Comments on Covariance Data of JENDL-4.0 and ENDF/B-VII.1

April 22, 2014

M. Ishikawa, JAEA

Na-23 Inelastic (1/3)

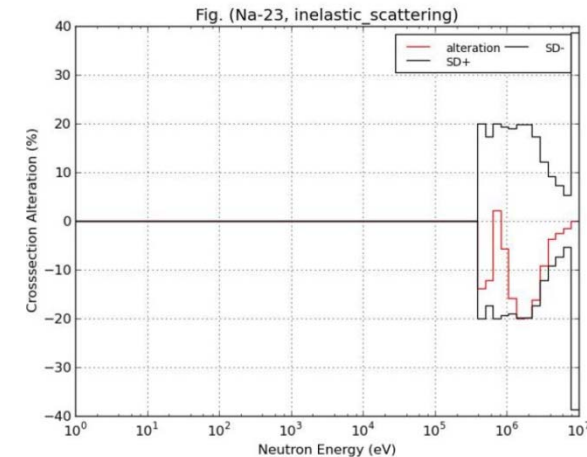
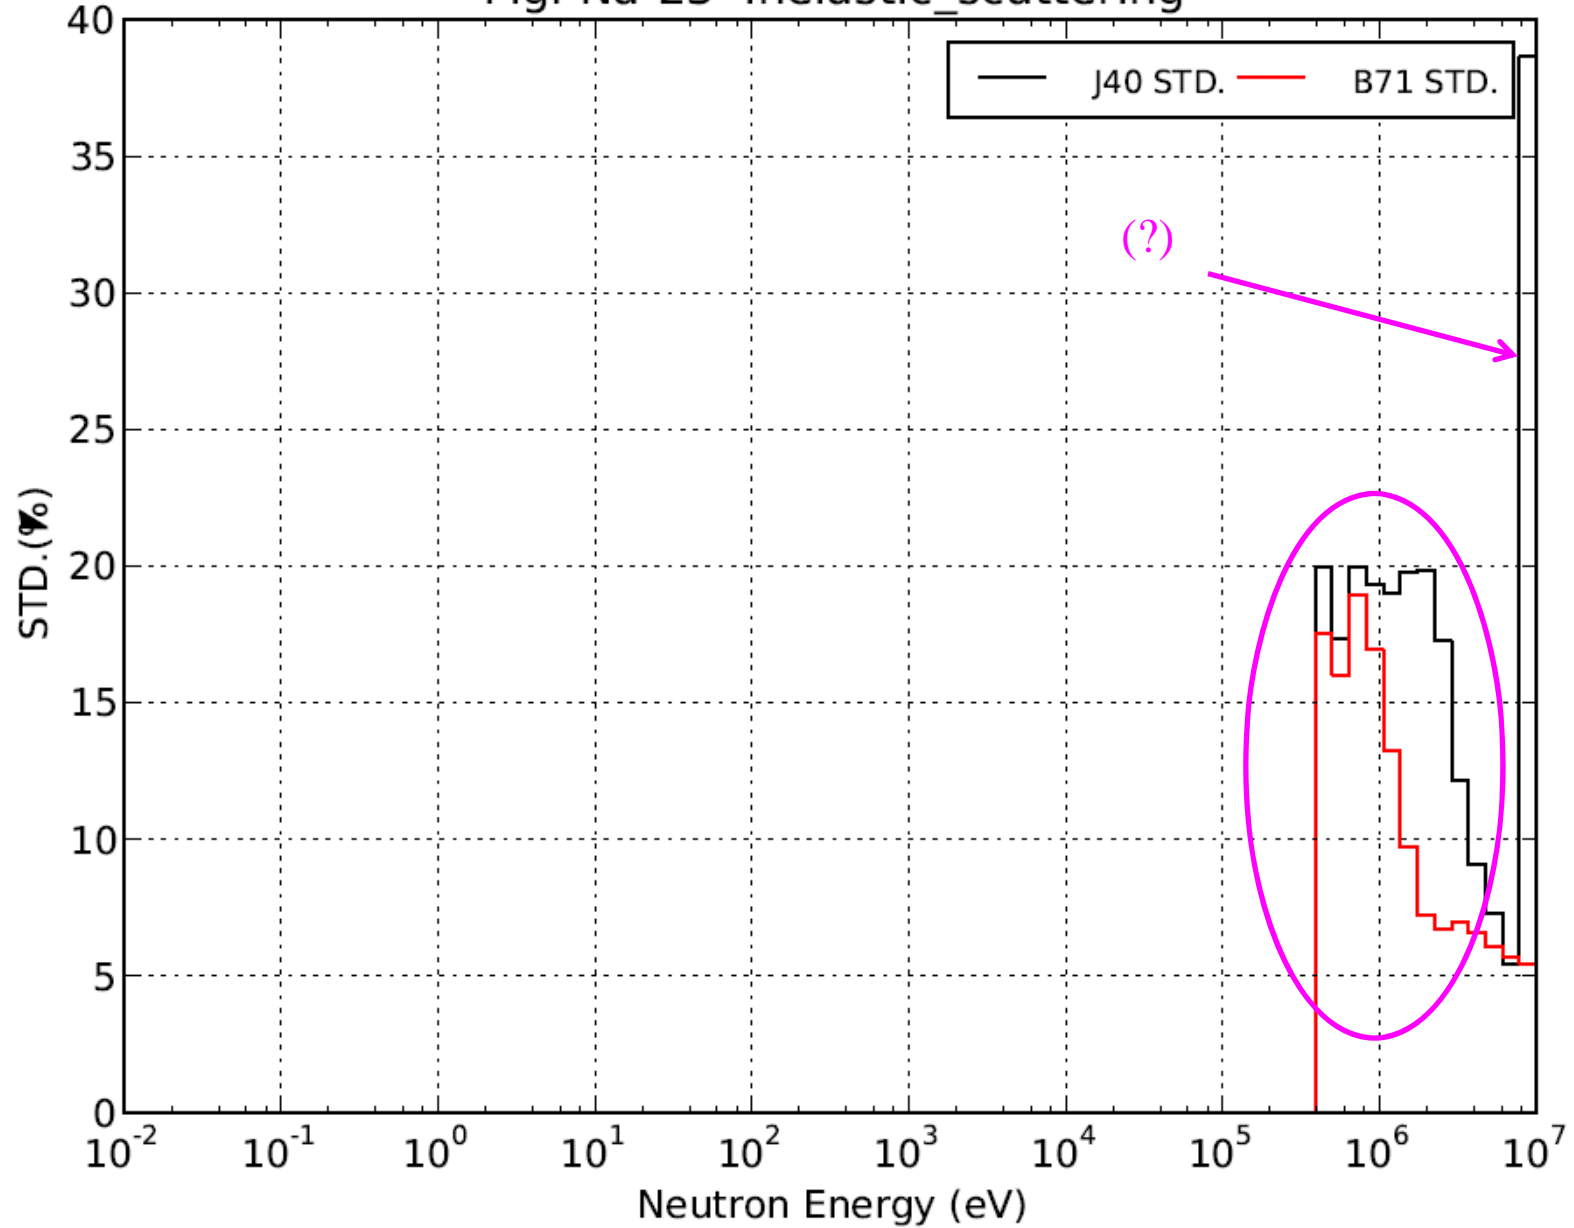
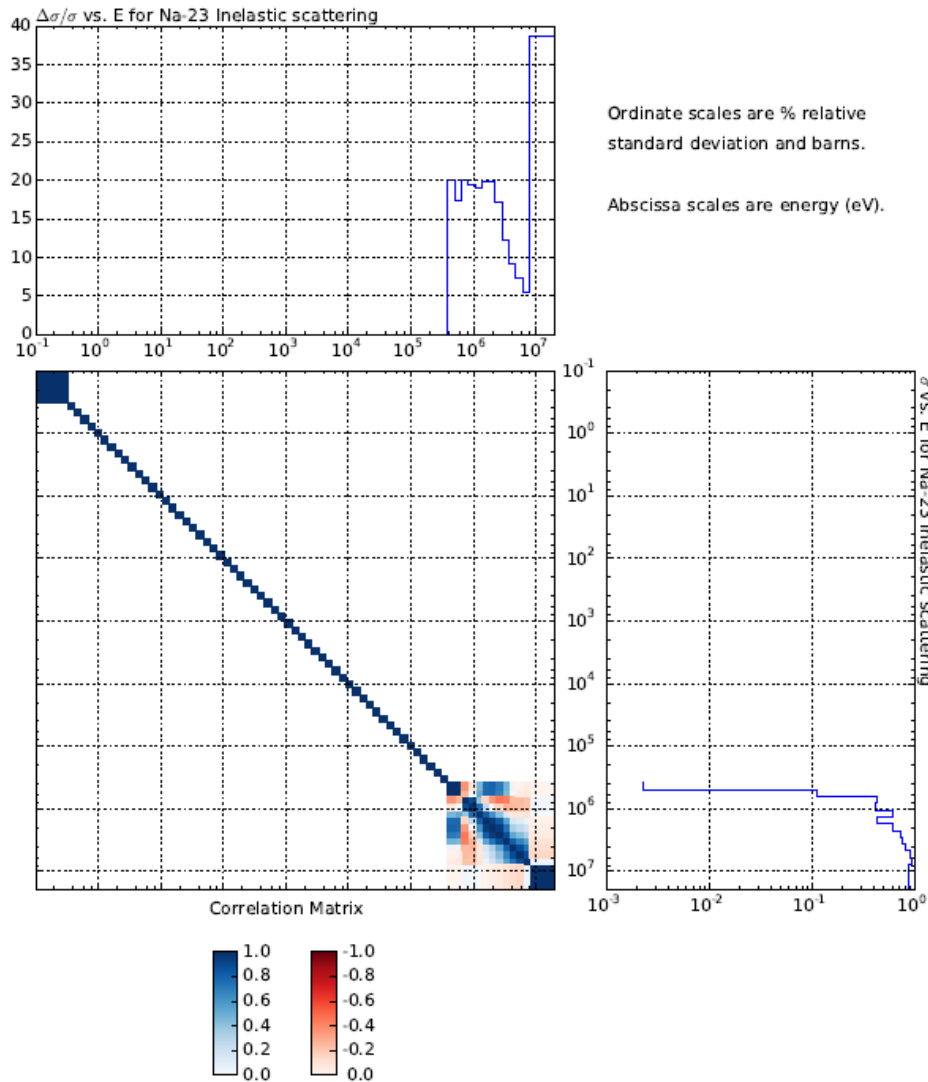
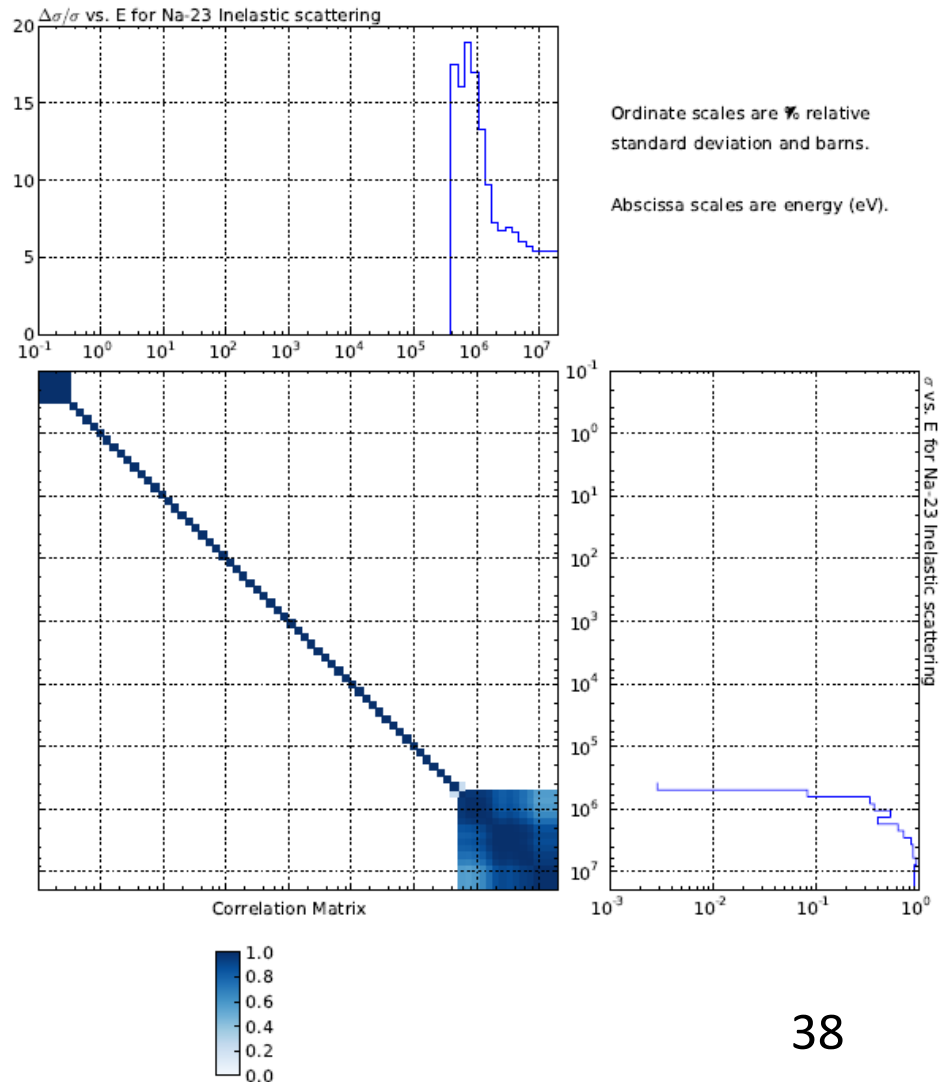
The **STD of ENDF-7.1** monotonously decreases from **17% at 1MeV** to **5% at 6MeV**, on the other hand, that of **JENDL-4.0** keeps constant value of **20% until 3MeV**, and monotonously decreases to 5% at 6MeV. Consequently, the **STD difference** of two libraries are **more than double** in the important **2~3 MeV** region.

The cross-section of ENDF-7.1 was evaluated with EMPIRE-excitation pre-equilibrium model using the RIPL library^(E-4, p.8), while that of JENDL-7.0 adopted the results of TNG code (1986), and the first excitation level was multiplied by a factor of 1.25^(J-3), according to an analytical result of an integral experimental related to neutron penetration in thick sodium layers at ORNL. The covariance of two libraries are evaluated with KALMAN^(J-3, E-4), but no information related to the large STD differences.

SG39 had better **ask the physical reason** of the **large STD differences** to both **JENDL-4.0** and **ENDF-7.1** evaluators.
